**VILLAGE OF VERNON HILLS
ORDINANCE 2023-130**

**AN ORDINANCE GRANTING PRELIMINARY AND FINAL SITE PLAN,
LANDSCAPE PLAN, AND ARCHITECTURAL PLAN APPROVAL FOR A NEW
WAREHOUSE / OFFICE BUILDING FOR HEATHROW SCIENTIFIC TO BE
LOCATED AT 440 FAIRWAY DRIVE**

Heathrow Scientific – 440 Fairway Drive

Planning and Zoning Commission – Meeting Minutes
November 15, 2023 - 7:30 p.m.

PROPOSED ELEVATIONS

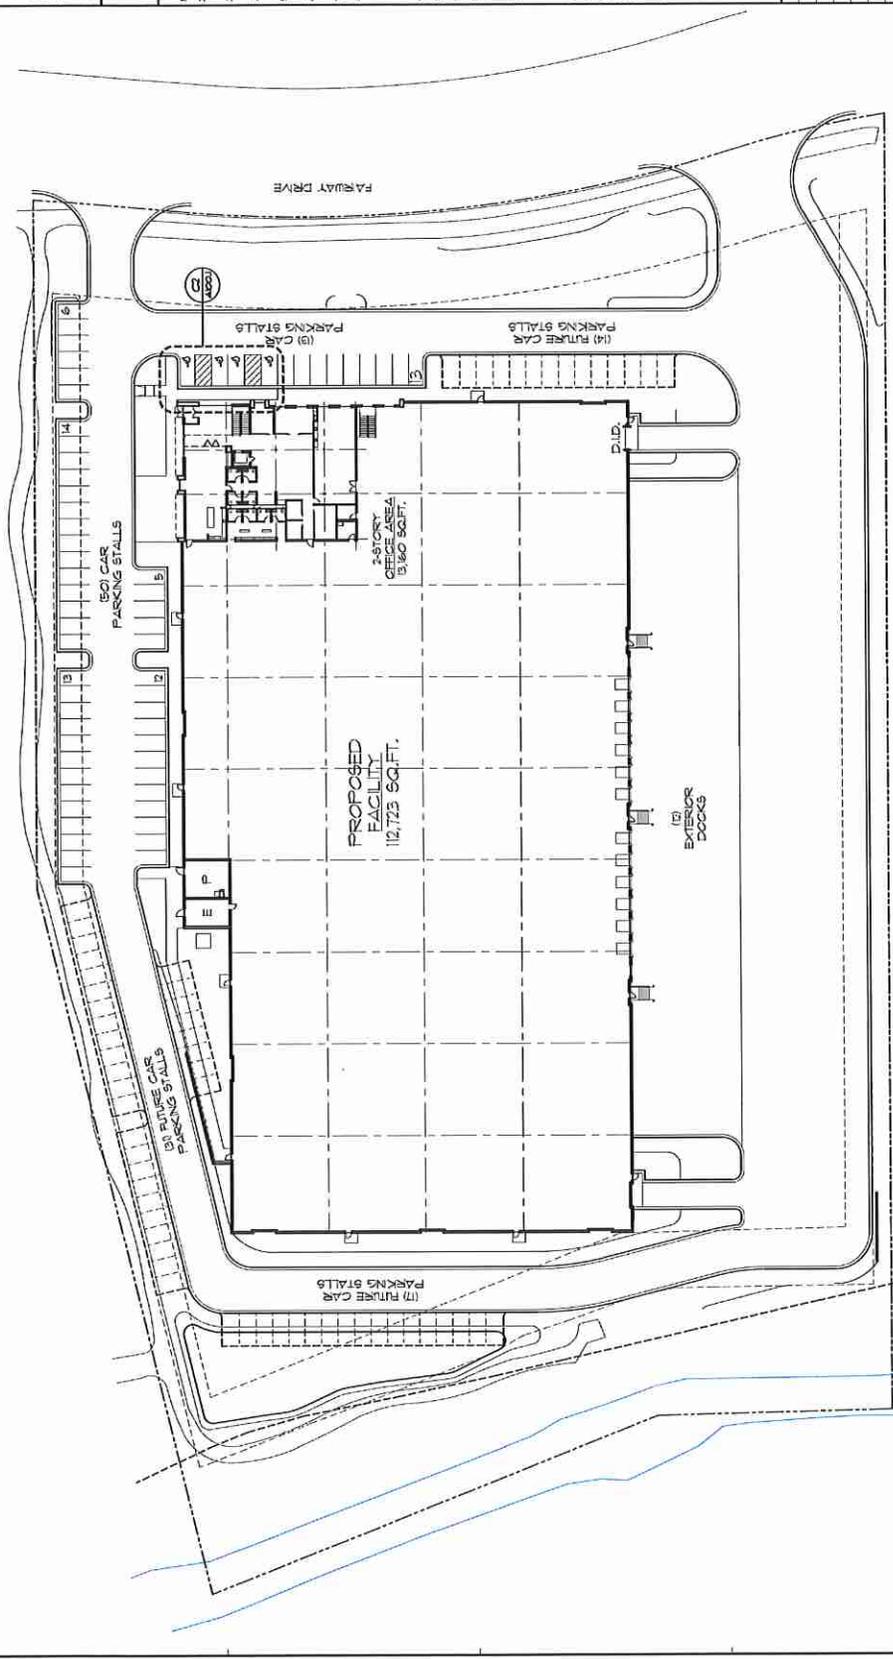
Commissioner Heidner asked about the durability of the composite material. Mr. Ahrens stated that it is a commercial grade product (Nichiha panel) often used on McDonald's and Burger King. It has been in use for a while. It does not require staining.

Chairman Morris requested clarification on the elevations. Mr. Olson confirmed that the north is considered the front. The east side faces Fairway Drive. Mr. Achs, Cornerstone Architects, added that they wrapped the additional design treatment on the east side because it was more visible.

Commissioner Fluno requested a description of the sign plans, and noted that the plans show signage on the east elevation. Mr. Olson stated that they are unsure at this time, but there is an existing monument sign that may be re-used.

Chairman Morris asked whether the future dock doors on the elevations were intended to accommodate growth of Heathrow or addition of a tenant. Mr. Ahrens stated that they are unsure. Growth may require more docks, but the additional docks also provide options for sale or division. Mr. Achs added that extra dock doors are typically illustrated on the elevations of precast warehouse buildings so that the walls can include reinforcement at appropriate locations.

440 NORTH FAIRWAY DRIVE
VERNON HILLS, ILLINOIS
GEOMETRIC PLAN

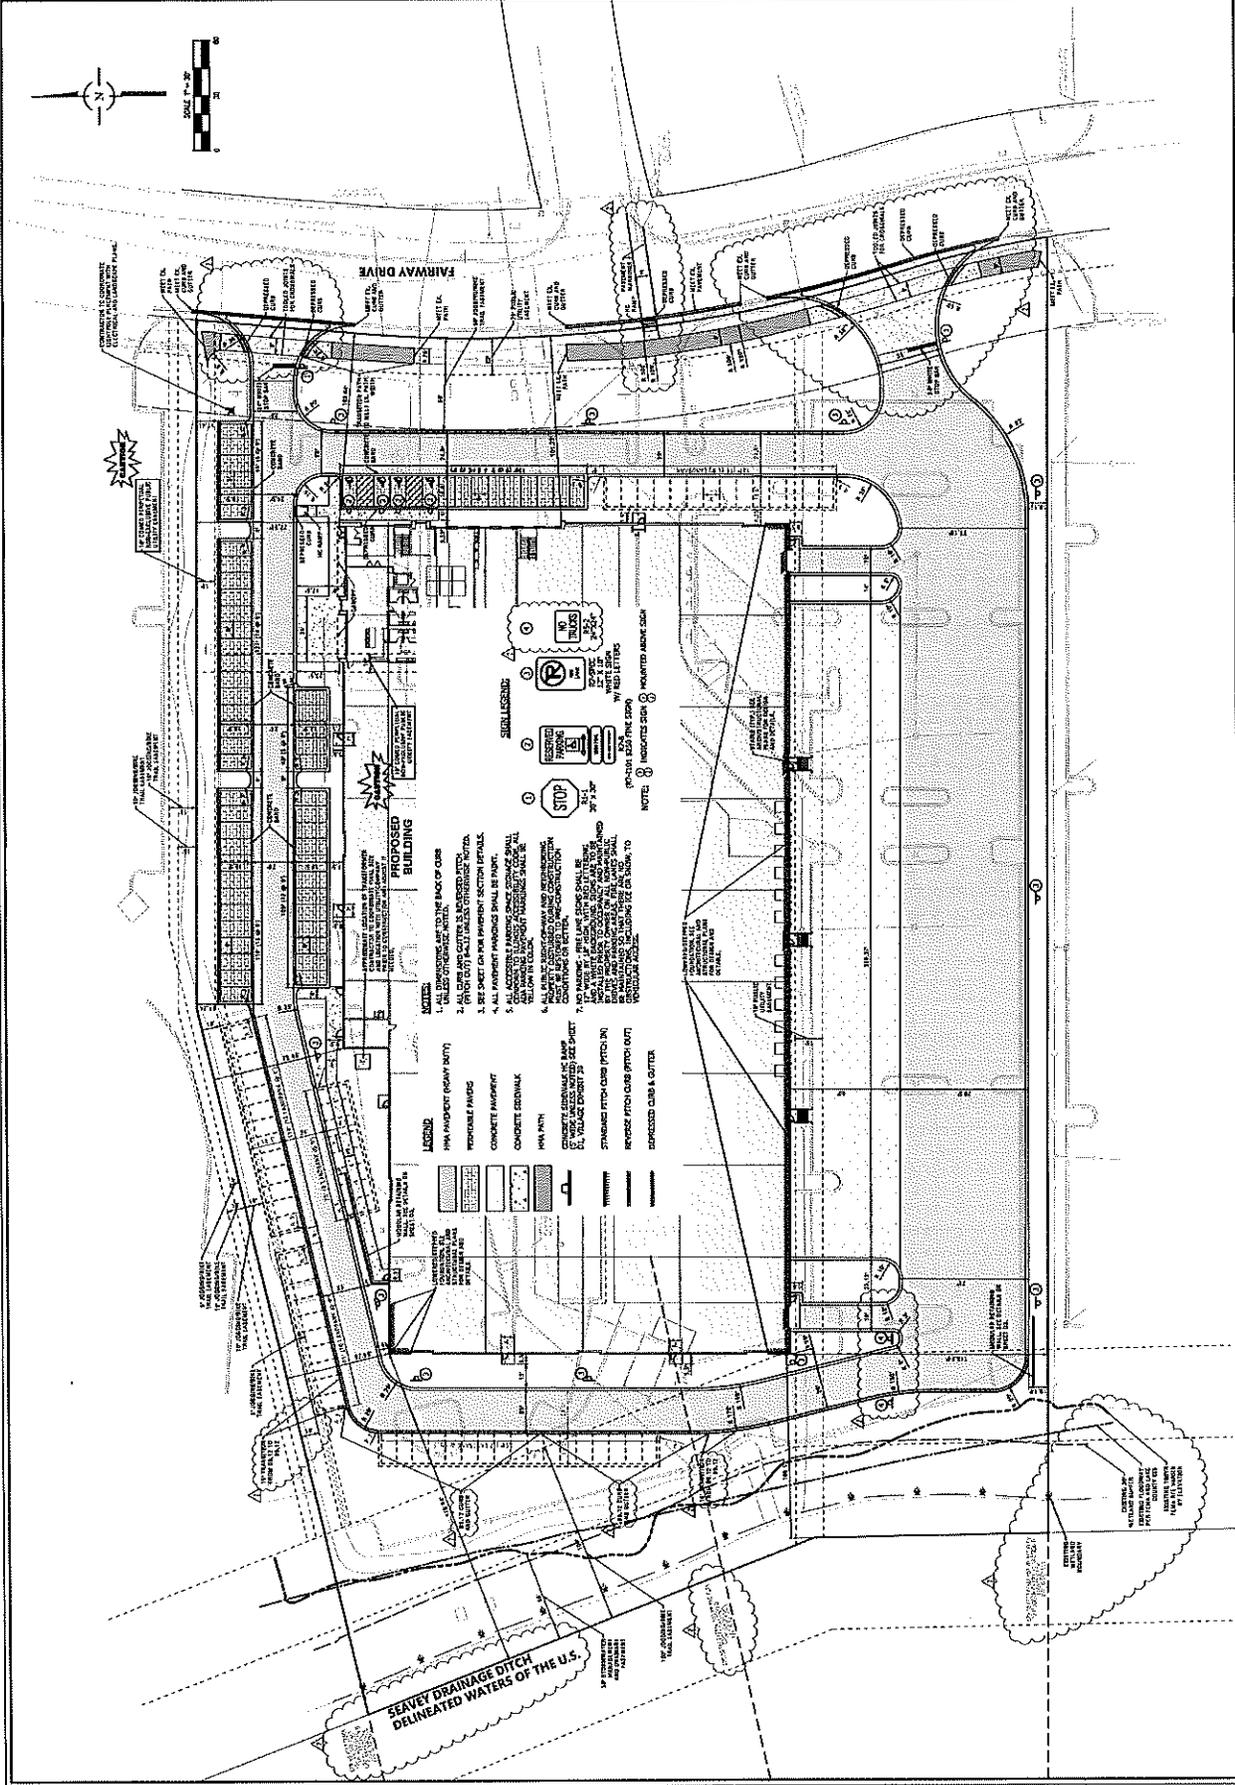
Commissioner Heidner questioned whether the code required the driveway to maintain a specific separation from the lot line. The curve of the driveway approaches the south lot line. Director Jennings stated that there is a maximum driveway width of 36 ft in the code but it can be flared out where it joins the roadway.

Commissioner Heidner asked whether the driveway was being relocated. Mr. Olson explained that the north drive is in the existing location and the south drive is shifting farther south. Commissioner Heidner questioned the function of the jog in the driveway. Director Jennings suggested that it is likely bent so that it hits the street at a 90 degree angle, and is flared for the turning radius.

Commissioner Heidner referred to the bike path on the site plan. Mr. Olson explained that it currently goes from the bridge on the west, along the north property line, and then along Fairway.

Chairman Morris asked whether the proximity to the pond was an issue. Director Jennings thought it would be an issue if there was an immediate drop off but not if there is a transition area with a gradual slope.
